ENGINEERING CHANGE NOTICE

Proj. ECN B-714-24

BLOCK 5: B-714, GROUT VAULT PAIR (218-E-16-102 & 103) (218-E-16-104 & 105) / ER8007
BLOCK 6: 218-E-16-102 & -103 and 218-E-16-104 & -105
BLOCK 9: ECN B-714-7, -9, -10, -15, -19, -20
BLOCK 8: SPECIFICATION B-714-C2, ~~REV 0~~ 2-7-90 (V-B714C2-003, REV 0) SEE PAGE 9 & 10

VAULTS 218-E-16-102 & 103
CIVIL/STRUCTURAL CHANGES TO DRAWINGS

KAISER ENGINEERS HANFORD	ENGINEERING CHANGE NOTICE SKETCH					
Ref. Dwg. H-2-78502	Sh. 4	Rev. 0	Prepared By G. KUBINSKI	Checked By	ECN No. B-714-24	Page 27/28

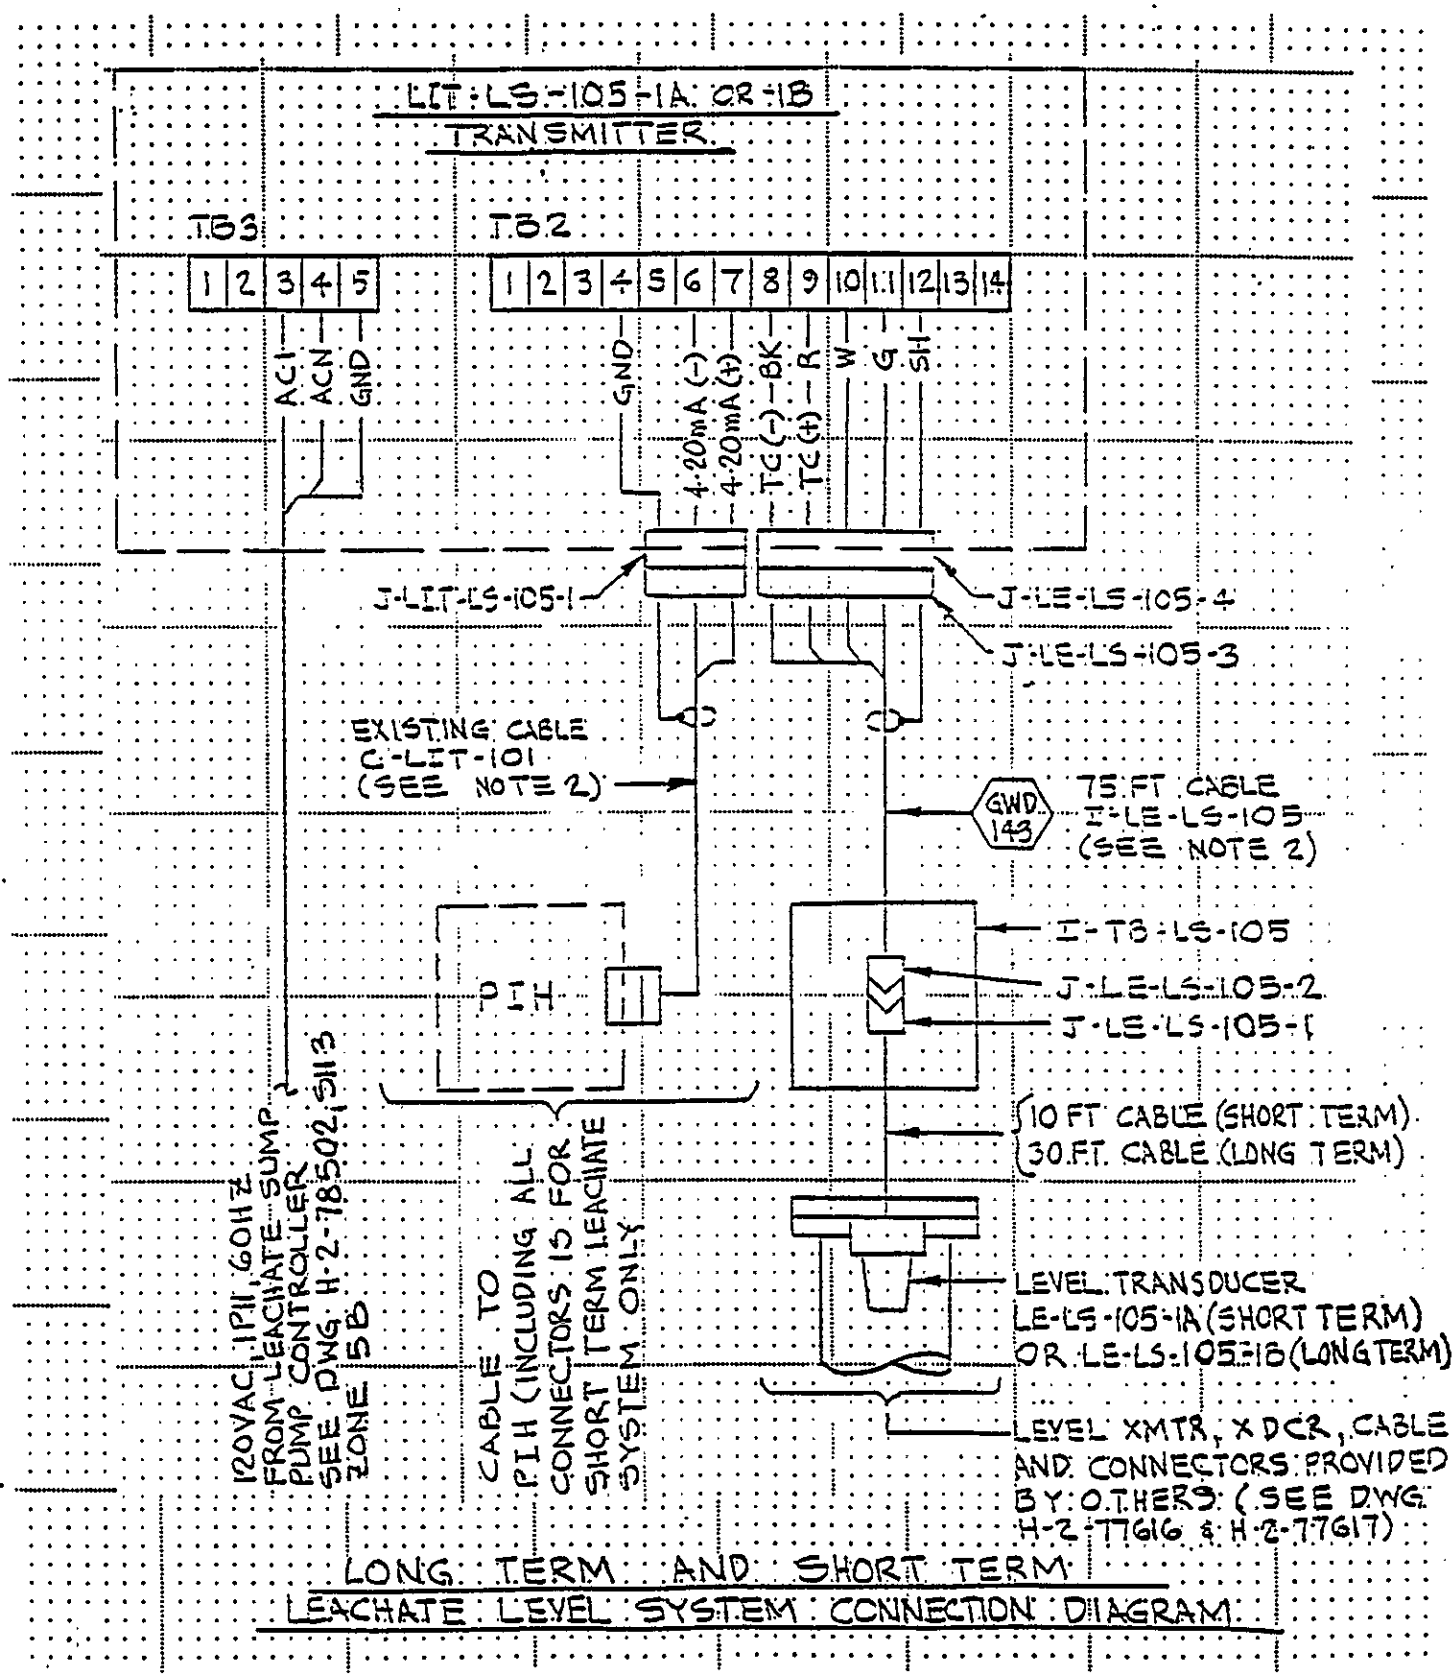
47) H-2-78502, SH 4, REV 0
Add CONNECTION DIAGRAM as shown on page 27 of this ECN.
